<b>REFERENCE:</b>	<b>TSB:</b> 08-174-23 <b>GROUP</b> 08 - Electrical	<b>Date:</b>	July 15, 2023	<b>REVISION:</b>	—
<b>VEHICLES AFFECTED:</b>	2021 - 2023 (WD) Dodge Durango This bulletin applies to vehicles built on and before June 15, 2023 (MDH 0615XX) equipped with the following: Global Telematics Box Module (Sales Code RDG).		<b>MARKET APPLICABILITY:</b> <input checked="" type="checkbox"/> NA <input type="checkbox"/> MEA <input type="checkbox"/> SA <input type="checkbox"/> IAP <input type="checkbox"/> EE <input type="checkbox"/> CH		
<b>CUSTOMER SYMPTOM:</b>	<p><b>Customers may experience one or more of the following:</b></p> <ul style="list-style-type: none"> <li>• Uconnect box requires service message (Fig. 1) .</li> <li>• Uconnect box backup “battery low” message on the radio.</li> <li>• WiFi hotspot streaming lost.</li> <li>• Rear mirror LED blinking after ignition cycle.</li> <li>• Uconnect App charge schedule / climate schedule setup issue.</li> <li>• Customer not seeing profile or other vehicle information on the mobile app.</li> </ul>

<b>CAUSE:</b>	TBM Software

**Fig. 1**  
**Uconnect Box Error Message**

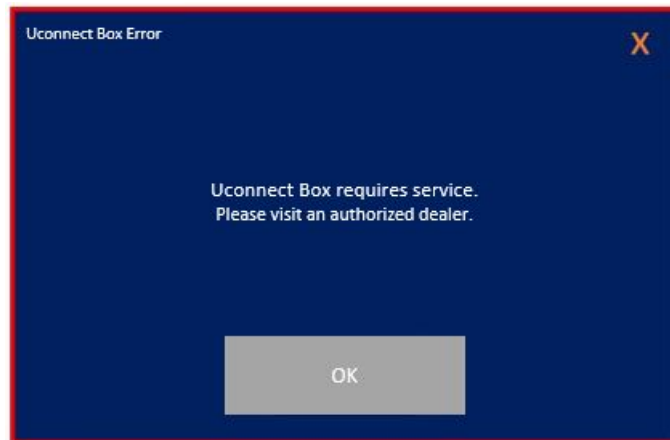
Message display on the radio screen, “Uconnect Box requires service. Please visit an authorized dealer.” (Fig. 1) , with no active or stored Diagnostic Trouble Codes (DTC)s set by the TBM.

This bulletin involves updating the TBM software from 4.27i to 4.36.

1. Reprogram the TBM 2.0 with the latest software 4.36. Detailed instructions for flashing control modules using the wiTECH Diagnostic Application are available by selecting the application's "HELP" tab.
2. Clear all DTCs that may have been set in any module due to reprogramming. The wiTECH application will automatically present all DTCs after the flash and allow them to be cleared.
